Big Darby Accord Advisory Panel

Case #AP-20-01

Request: Requesting approval of a 6 lot single-family residential

Development Review Checklist To be completed by Agency Staff Revised 10/1/08

Proposed Grading Plan **Existing Grading**

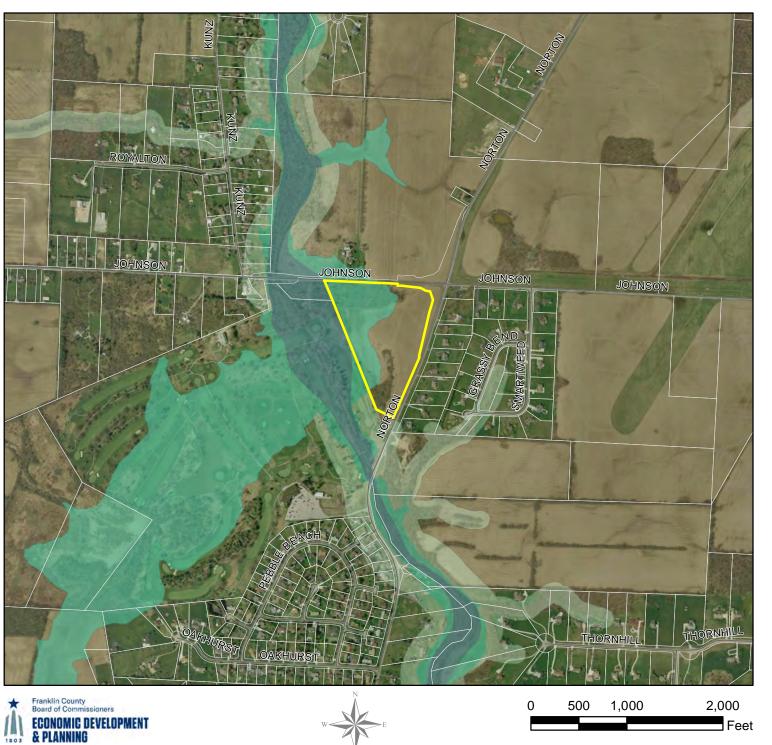
Lots 1-4 will maintain current drainage paths. A grading plan was submitted which indicates grading will change on lots 5 and 6 to drain away from potential homes and septic systems. The Subdivision will be required to comply with the Franklin County Stormwater Drainage Manual.
